AEROSTAR SERVICE BULLETIN 130

02/20/92

Subject: Replacement of aluminum support tubes on Classic Limited Stretch (CWS) gondola (P/N 51620) or Classic Limited (CW) gondola (P/N 13860) or Classic Custom (CWV) gondola (P/N 15325).

AMENDMENT #1
AEROSTAR SERVICE BULLETIN 130

Note: See Figure 1, Page 5

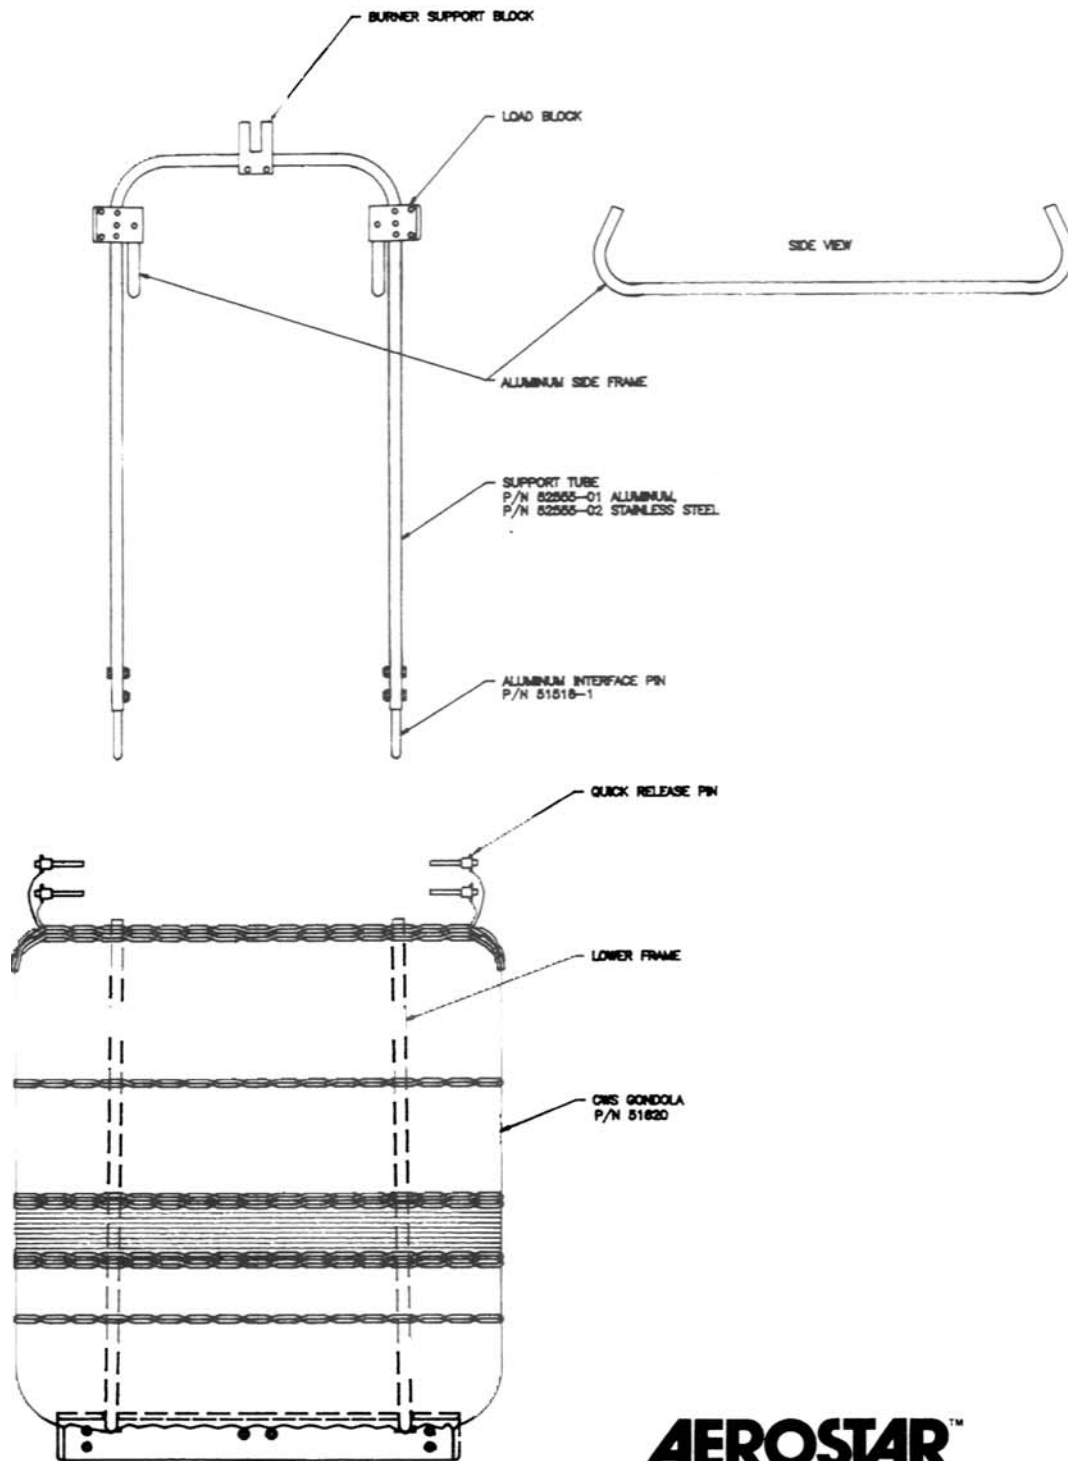
Support Tube
Replacement
Procedure:

- 1) Install aluminum support tubes in basket. It is imperative that the support tubes be installed in the basket to ensure a proper match and alignment of the aluminum interface pins during reassembly.
- 2) Insert quick release pins, fastening lower frames to support tubes.
- 3) Leaving quick release pins which connect basket and superstructure support tubes installed, remove bolts at bottom of support tubes. Remove support tubes from aluminum interface pins, leaving interface pins installed in lower frames.
- 4) Remove bolts which attach load blocks to aluminum support tubes (3 each load block) and remove load blocks.

- 5) Remove burner support block from aluminum support tube.
- 6) Install burner support block on stainless steel replacement support tube. Refer to P. 4-40a of ACAI manual.
- 7) Install load blocks on stainless steel support tube.
- 8) Place new support tubes on aluminum interface pins still installed in lower frames. Be sure to push support tubes down as far as possible. Install aluminum side frames, completing superstructure assembly.
- 9) Reinstall bolts connecting stainless steel support tube and aluminum interface pin.

If bolts can not be easily and readily inserted through stainless support tube and aluminum interface pin, aluminum pins must be replaced as well. (This may be the case with older 2-Pt. suspension baskets which were converted to 4-Pt.) Refer to PG. 4-37 of ACAI.
